172 Central Ave
Subject Property
Built 1883
“Italianate”
Level 1

Re: Structural Review
Private Residence at 172 Central Avenue
Our file No. 18-15-0142

Unsafe Building – Order to Make Safe

RE: 172 Central Ave Site Inspection

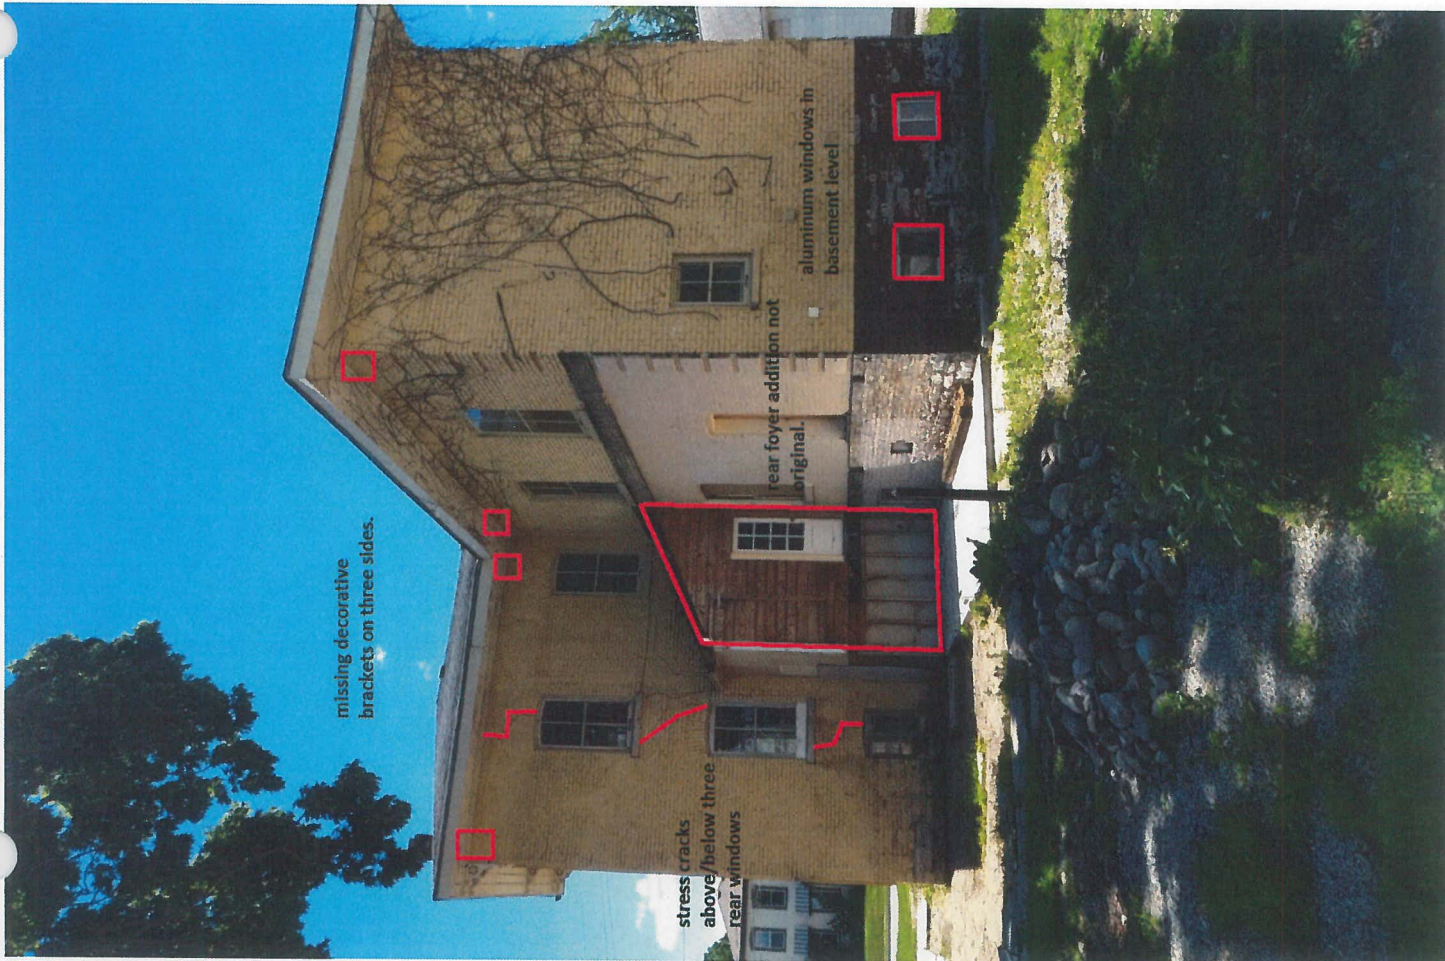
exterior load bearing wall stress
cracks penetration thru-out
entire wall cavity (single wythe
load bearing masonry)

missing decorative brackets on three sides.

stress cracks above/below three rear windows

rear foyer addition not original.

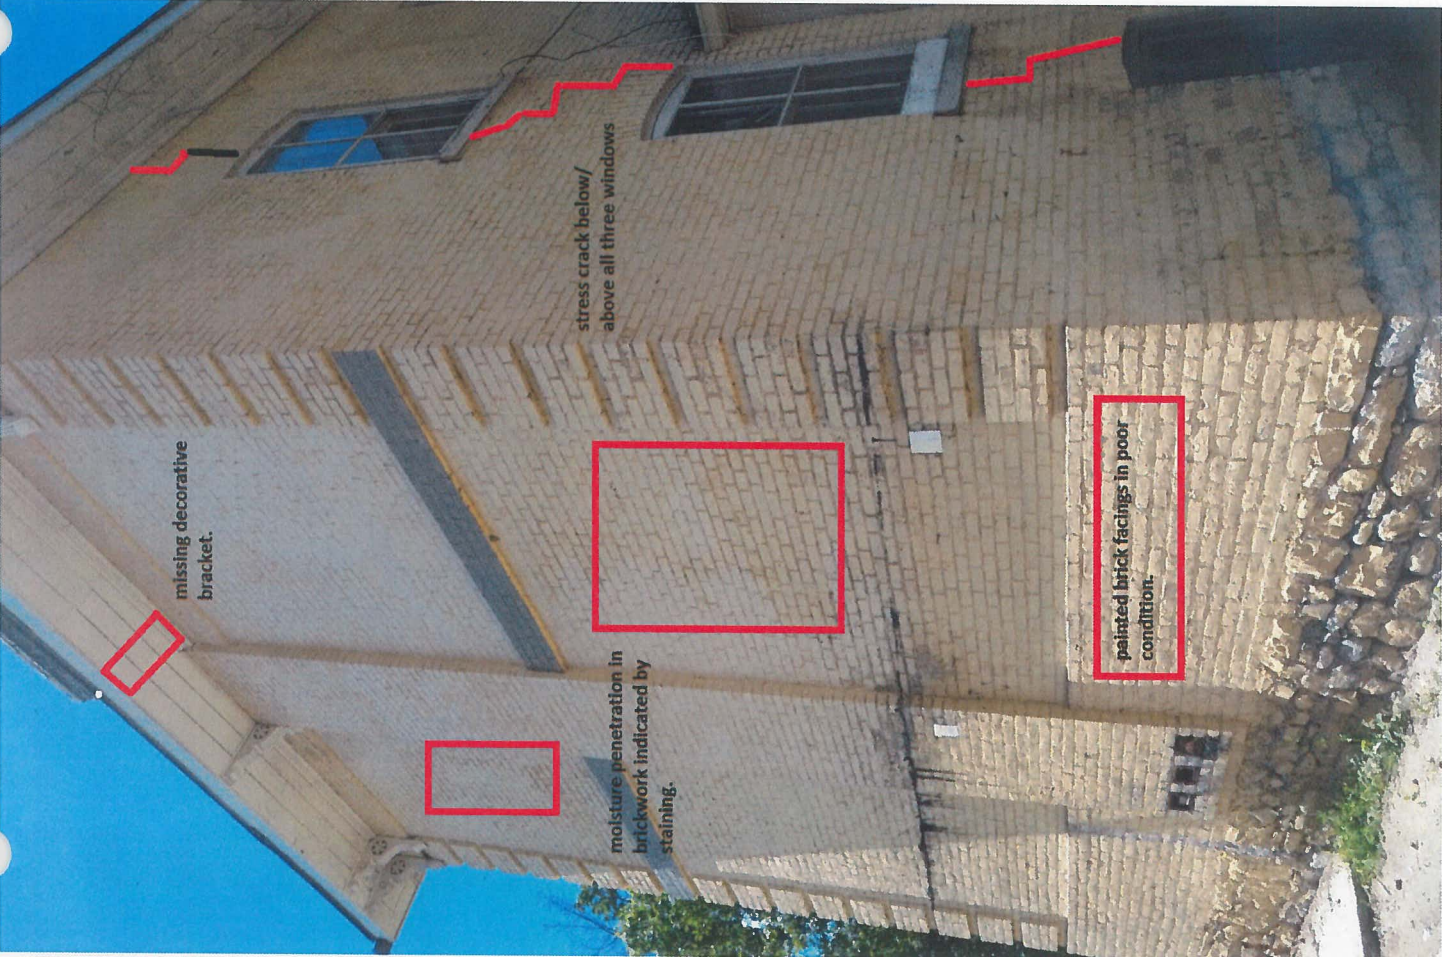
aluminum windows in basement level

missing decorative bracket.

stress crack below/
above all three windows

moisture penetration in
brickwork indicated by
staining.

painted brick facings in poor
condition.

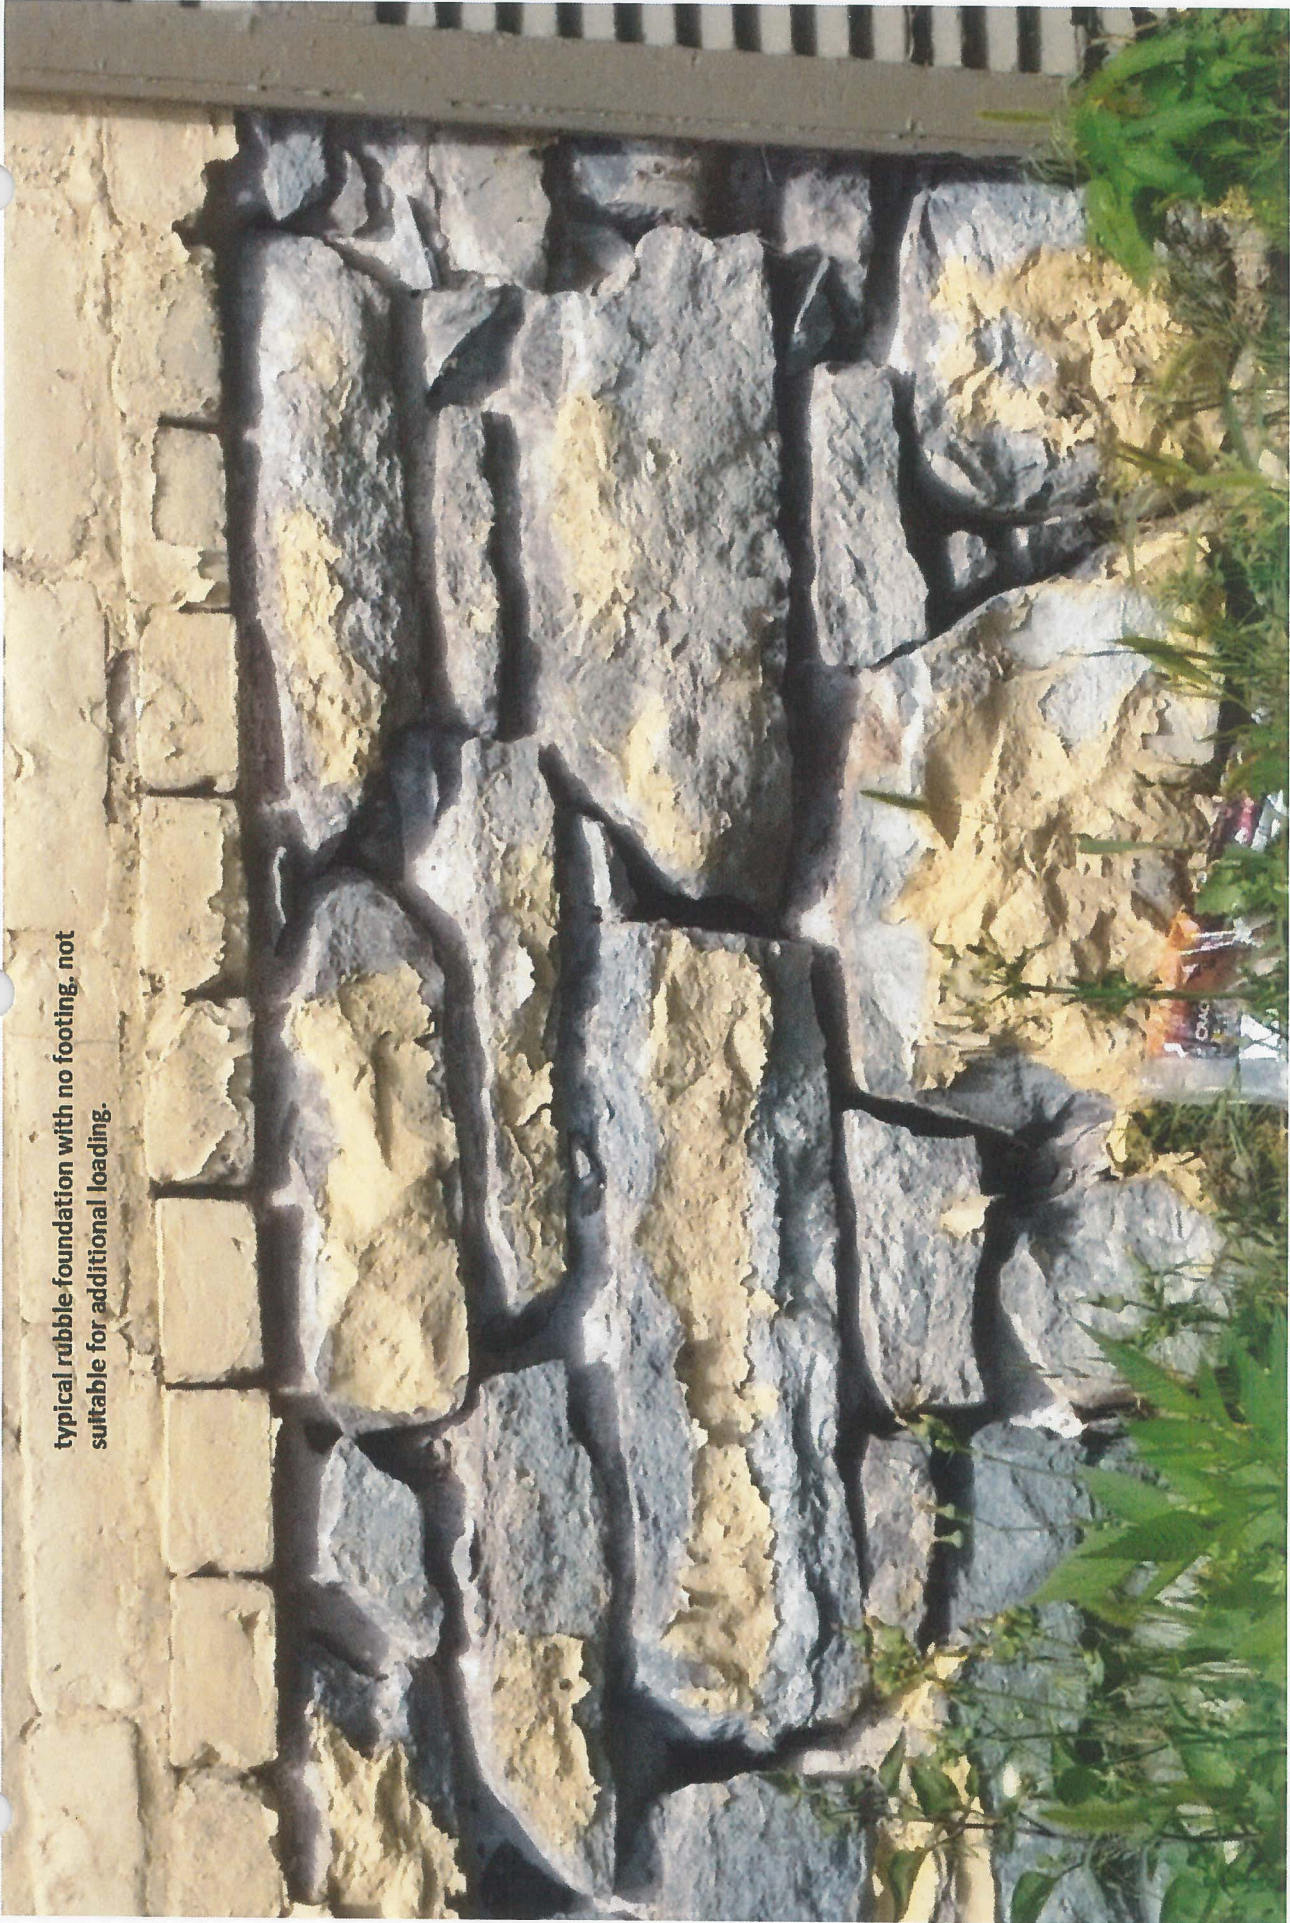
typical rubble foundation with no footing, not suitable for additional loading.

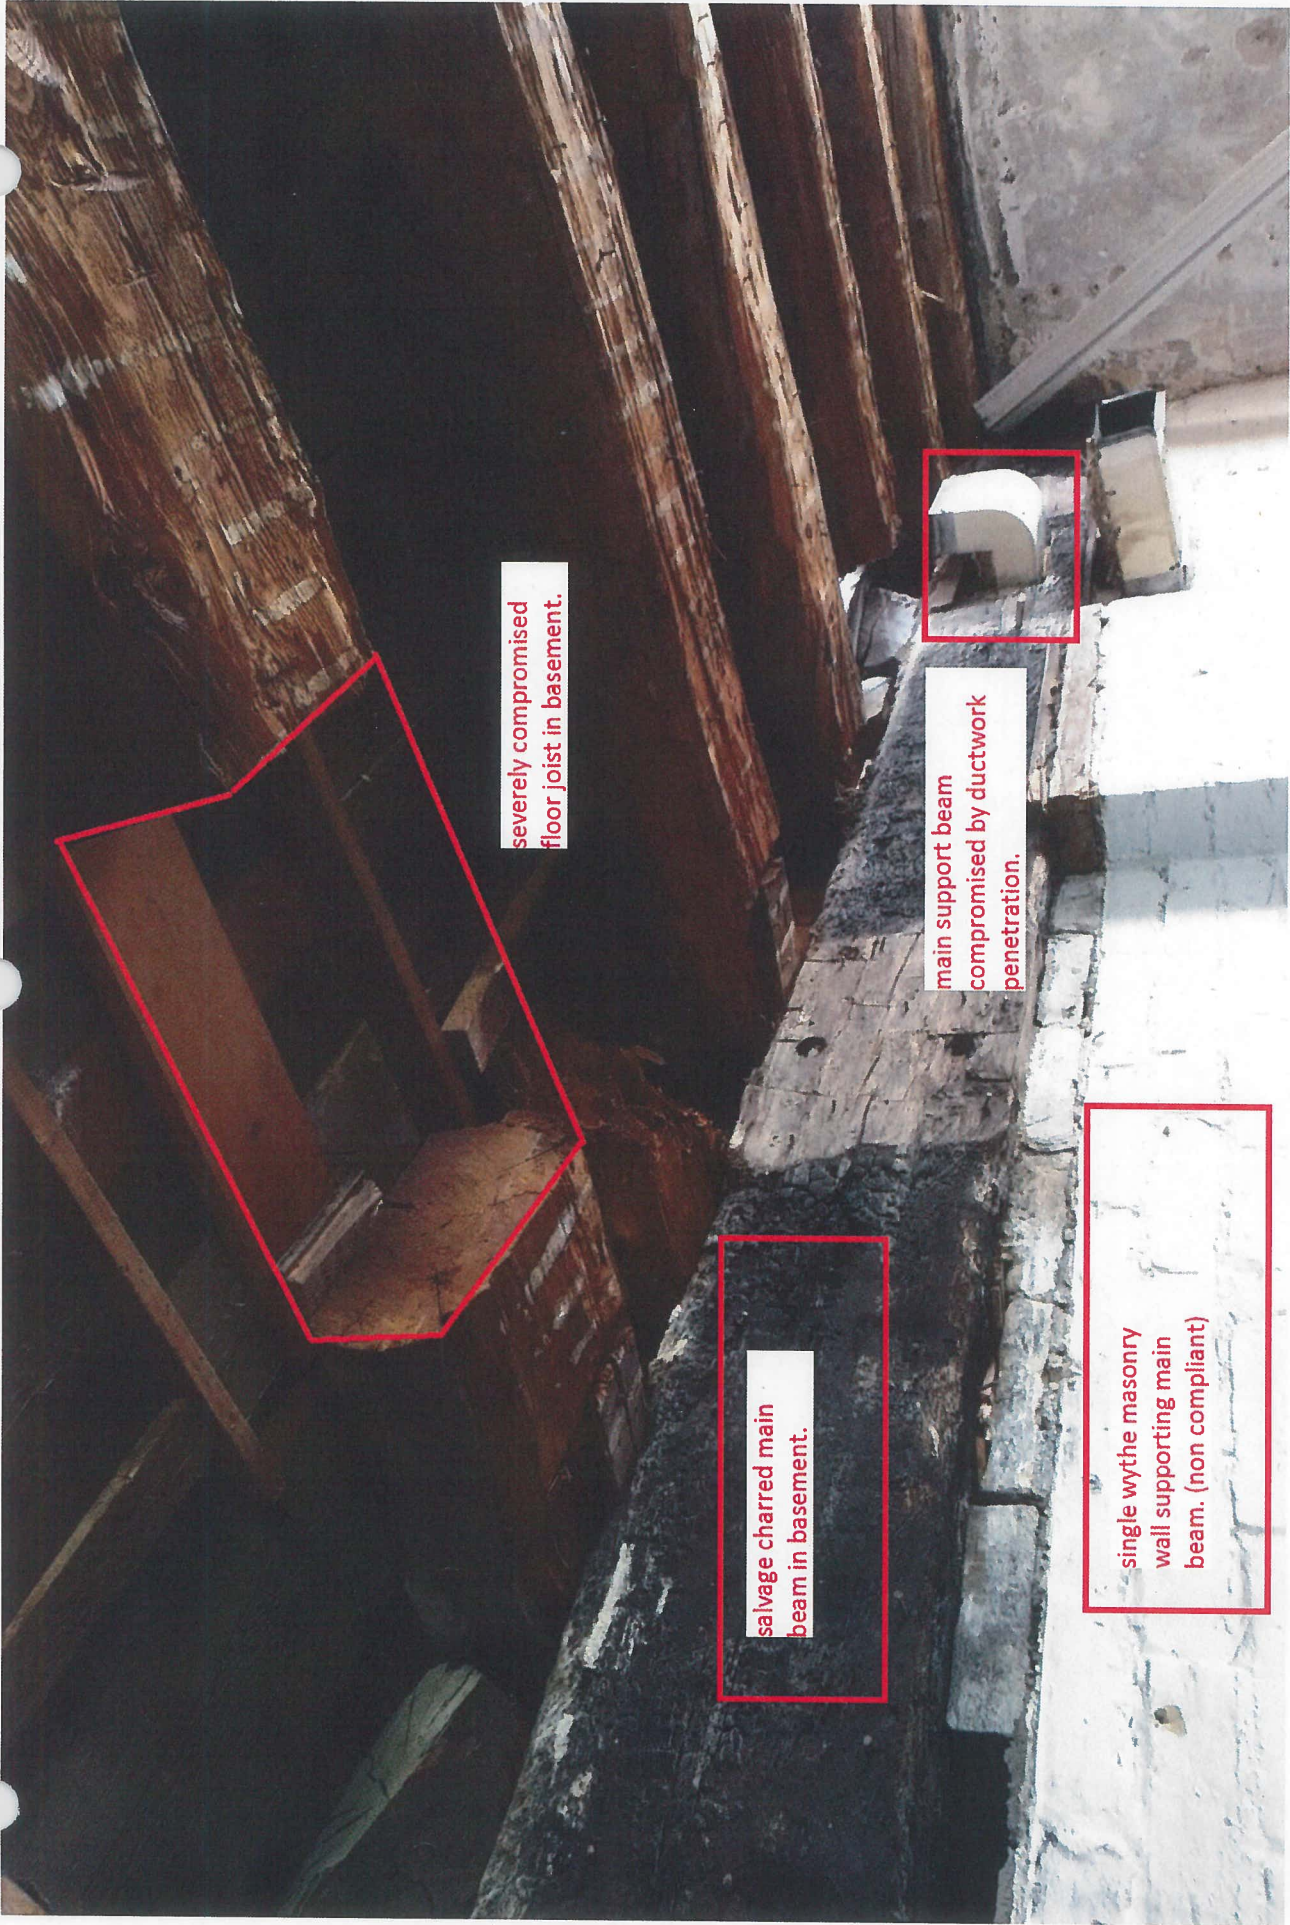
major portion of main beam support removed in basement. floor joists floating. (approx. 4'-0" removed)

severely compromised floor joist in basement.

main support beam compromised by ductwork penetration.

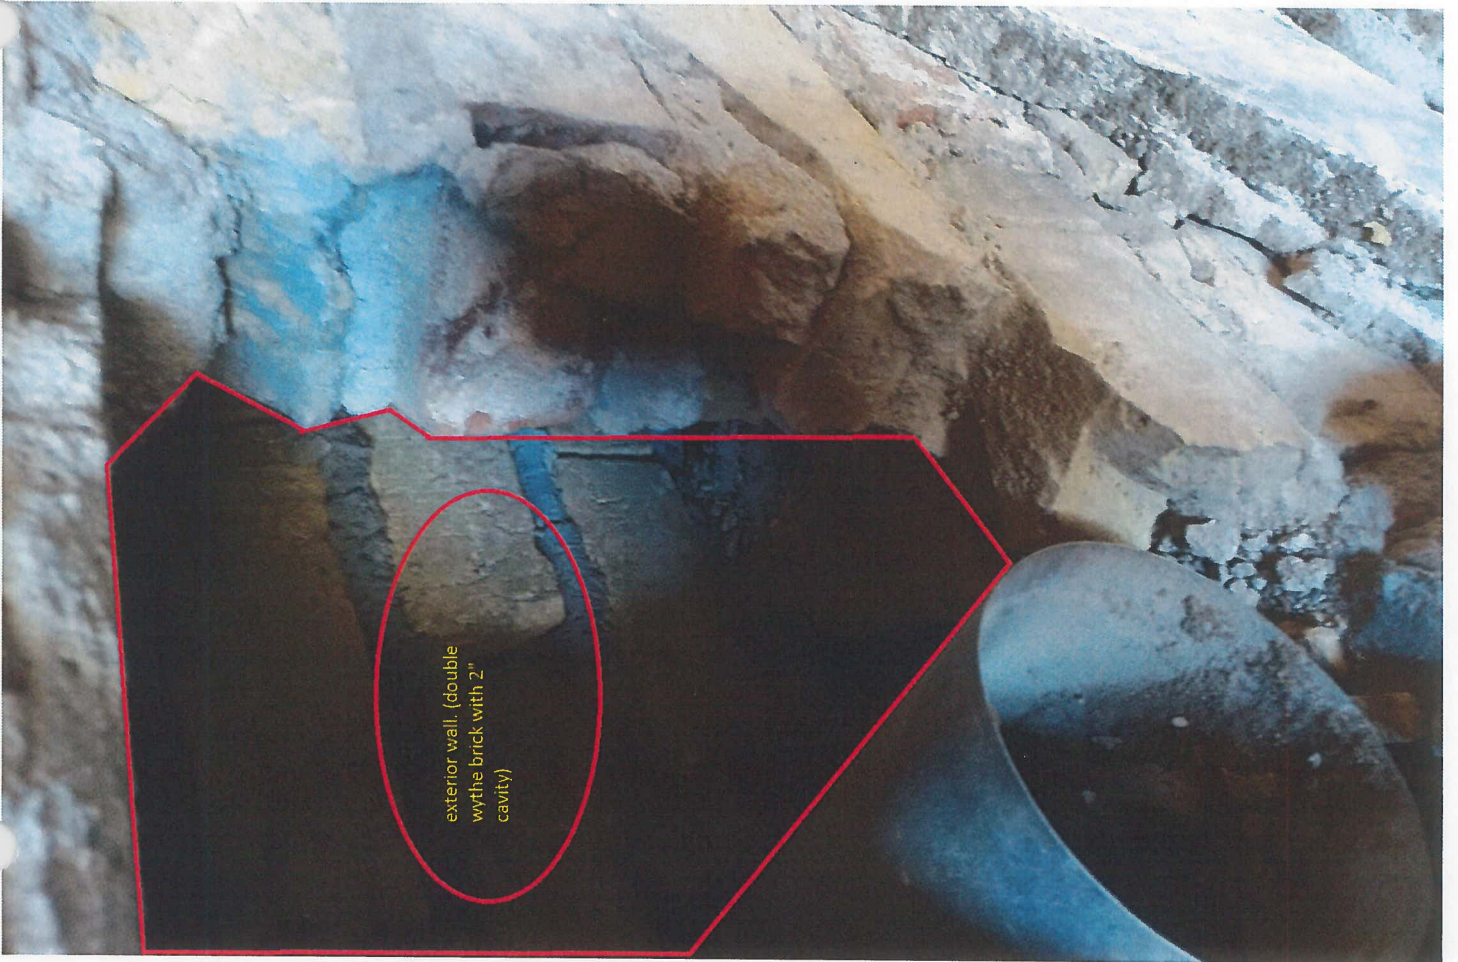
salvage charred main beam in basement.

single wythe masonry wall supporting main beam. (non compliant)

splitting floor joists
resting on main support
beam.

salvaged-charred main support beam in basement.

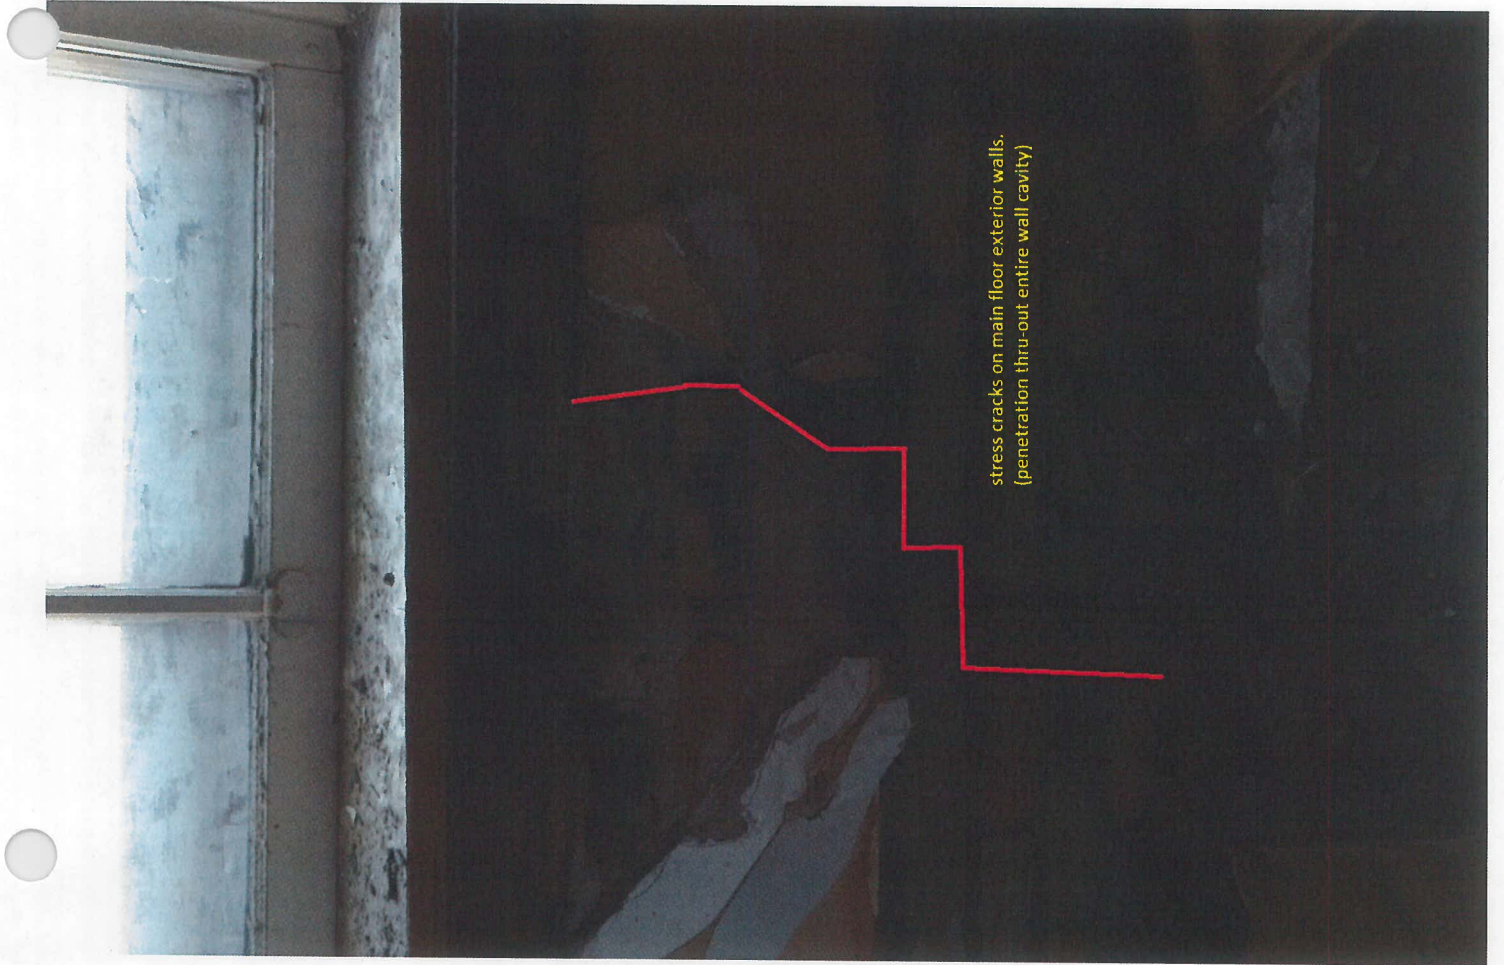
exterior wall. (double
wythe brick with 2"
cavity)

stress cracks on main floor exterior walls.
(penetration thru-out entire wall cavity)

severely split and dry rot floor joists. (throughout many locations of building)

cantilevered floor system separating
and causing outward thrust on
exterior load bearing single wythe
walls.

configuration of load bearing wall
members not in proper orientation.
(load bearing strength is
compromised)

timbers above staircase
floating. (original
supports have been
altered)

headroom height in
stairwell 6'-10" (non-
compliant.) salvaged
staircase not custom built
for house.

interior view of rear
vestibule. (not
original)

shifted and cracked exterior load bearing masonry (main floor, single wythe.) penetration throughout entire wall cavity.

signs of moisture penetration.
